Removing Odometer Pause Wiring Modifications

TSB-54-375-FTL

Fig. 1, Allison Split Shaft PTO (SSPTO) Modification Diagram

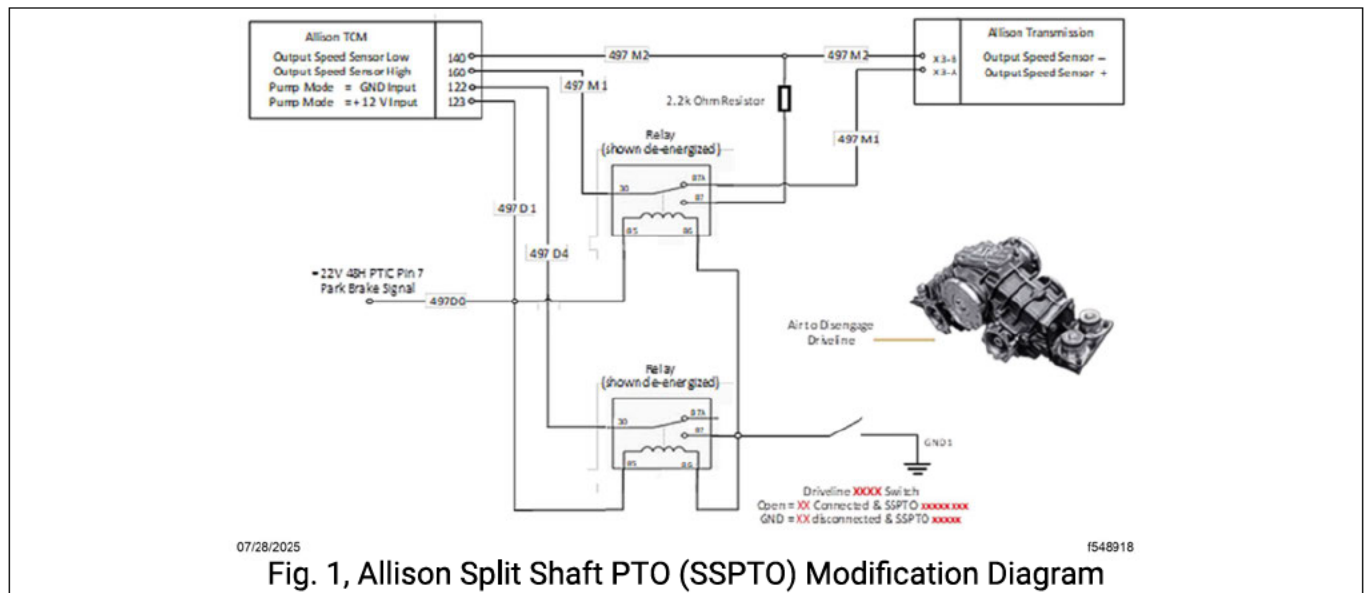
Figure 1 shows the modification diagram for the system to be removed.

⚠ Note: With the relays removed, the control signals, directed to the park brake signal node, and the driveline disconnect switch are to be connected to the Allison Transmission Control Module (TCM) pins 122 and 123. Control signals to TCM 123 and 122 are to be re-established. The two relays no longer sequence signals to the TCM.

1. Remove the 2.2K ohm resistor. Leave the circuit 497M2 intact.

- Remove both ends of 497M1 from the relay and connect 497M1 again. Leave the TCM pin 160 and the output speed sensor pin X3-4 intact. The final configuration is shown in Fig. 2.

- Remove the remaining relay for the driveline status. Keep the wires 497D1 and 497D4 intact. These wires connect to the TCM pins 122 and 123 and are re-used.
- After the relay circuits are removed, the fourth gear lock-up function needs to be enabled by sending power to TCM 123 and a switch to ground for TCM 122 when the driveline is disengaged, and the SSPTO is engaged.
 - TCM 123 reflects the selection of pump mode by the operator and the application of the park brake.
 - TCM 122 indicates that the split shaft PTO is fully engaged, and the driveline is disengaged.
- After removing the relay circuits, for instructions to set the Single Signal Detect and Actuation Module (SSAM) and CPC5 parameters for the odometer pause function, see **TEM-54-00012: Odometer Pause for SSPTO**.
